NRC RAI Letter No. PTN-RAI-LTR-041

SRP Section: 02.05.01 - Basic Geologic and Seismic Information

NRC RAI Number: 02.05.01-18 (eRAI 6024)

Figure 2.5.1-274 Interpreted Versions of the Southern Half of Profile FS-08 in the Straits of Florida

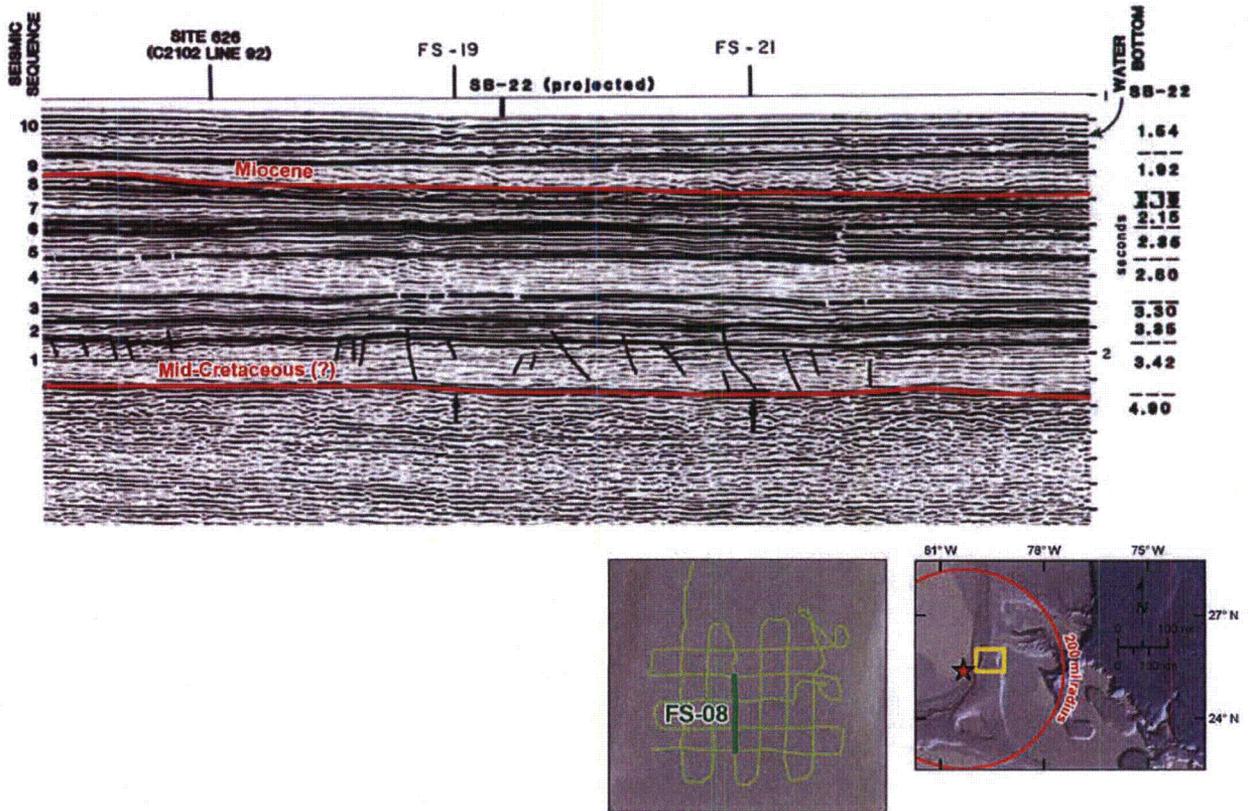
FSAR Figures 2.5.1-274 through 278 and 280, 281, and 287 shows annotated seismic sections, however the staff notes that more information is needed in order to evaluate the relative ages of deformation shown in these seismic cross sections.

In order for the staff to fully understand the regional site geology area and in support of 10 CFR 100.23, please indicate the ages and formation names, if known, of the various sedimentary strata on these figures. Please clarify what is the interpreted depth to faulted strata.

The seismic line in FSAR Figure 2.5.1-274 is from FSAR 2.5.1 Reference 785, hereafter referred to as Austin et al. (1988). Austin et al. (1988) identify 10 prominent seismic sequence boundaries above a mid-Cretaceous (?) target horizon; however, these sequences are not correlated with individual geologic formations. They interpret this target horizon as a buried shallow-water carbonate platform, with an Albian-Cenomanian (mid-Cretaceous) age. Similarly, Sheridan et al. (1981) (FSAR 2.5.1 Reference 424) hypothesize that this platform is mid-Cretaceous in age.

The only age information provided by Austin et al. (1988) for the prominent seismic sequence boundaries above the target horizon is for the 8/9 boundary (upper reflector in Figure 2.5.1-274, Figure 14 from Austin et al. (1988)), which is the only well-sampled part of the section at Site 626. They correlate the debris flows and turbidites sampled there with the Great Abaco Member of the Blake Ridge Formation, which would mean sequence 9 is composed of middle Miocene deposits. Austin et al. (1988) note that consistent fault offset is only seen at the sequence 1/2 boundary. One of these faults is interpreted to almost reach the 2/3 boundary, which lies at a depth of 1.74 kilometers (1.08 miles) beneath sea

level and roughly 940 meters (3080 feet) beneath the seafloor (assuming a mean water depth of 800 meters (2620 feet), see Table 5 and Figure 13 from Austin et al. 1988. This faulting occurred between the deposition of mid-Cretaceous and middle Miocene sequences.
